Defective Plumbing Installation

Collingwood.

Report Date: 25 July 2023

VCAT Reference:

FIGURE 5.3.1 OVERFLOW PROVISION

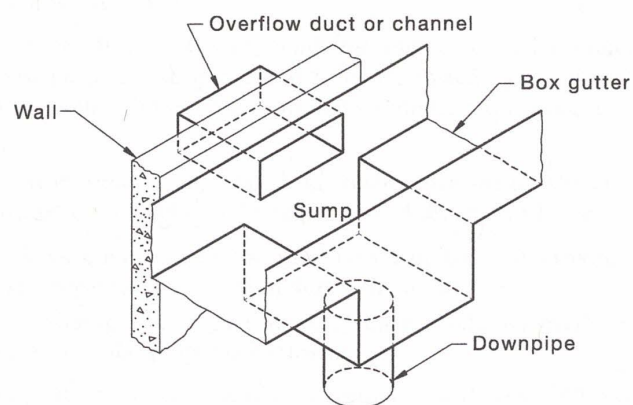
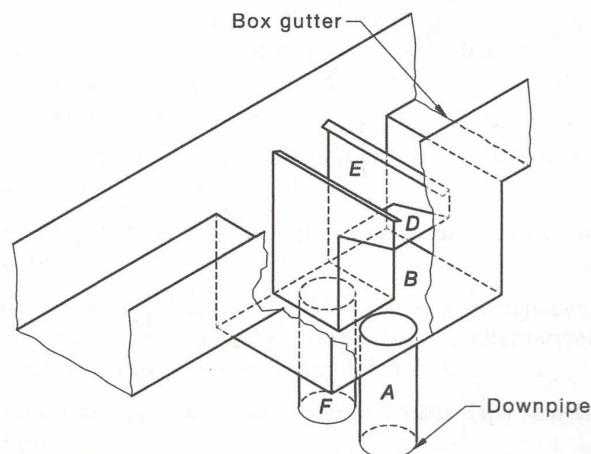
5.3 A non-conforming sump has been installed in the boxgutter in the front of the chimney. This sump is defective as follows;

- 5.3.1** The sump has not been set into the boxgutter correctly.
- 5.3.2** The overflow from the base of the sump has not been extended into the open, as required by the Deemed to Satisfy Standard SA HB39. The overflow is discharging into the ceiling of the residence.

The sump, the downpipe and the overflow from the sump will need to be removed and reinstalled in accordance with Deemed to Satisfy Standard SA HB39:2015 figure 5.3.1. (b), clause 5.3,1 (b)(Overflow provision). Refer to Appendix 3.

The reworking of the sump, the downpipe and the overflow will require the removal and replacement of the ceiling and also the recently installed ceiling boxing for the downpipe.

FIGURE 8.4(A) WALL AND STEP FLASHINGS

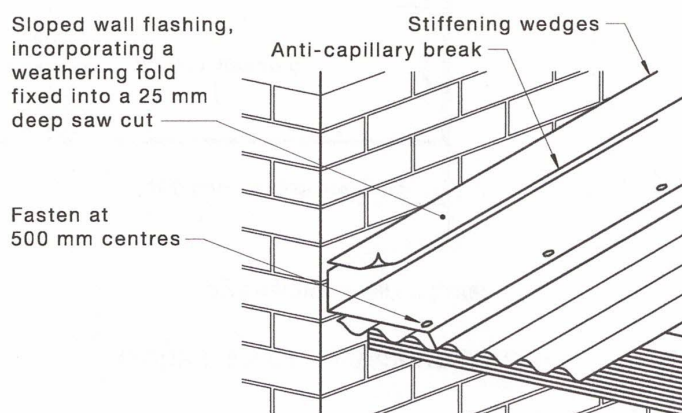
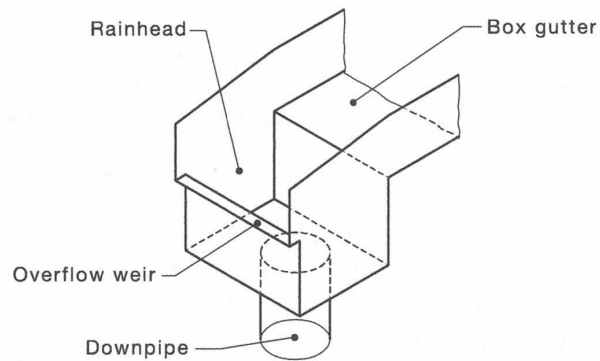
5.2 The soaker flashing on the front parapet has not been overflashed in accordance with the Deemed to Satisfy Standard SA HB39:2015, figure 8.4(A). (Refer Appendix 3) The rectification will require the following work;

- 5.2.1** The flashing removed, and the uneven render/mortar on the brickwork removed from the parapet.
- 5.2.2** The flashing replaced with fixings @ max. 500mm spacing.
- 5.2.3** An overflashing installed, such as a step flashing or a chased flashing.
- 5.2.4** Replace the render/mortar above the flashing.
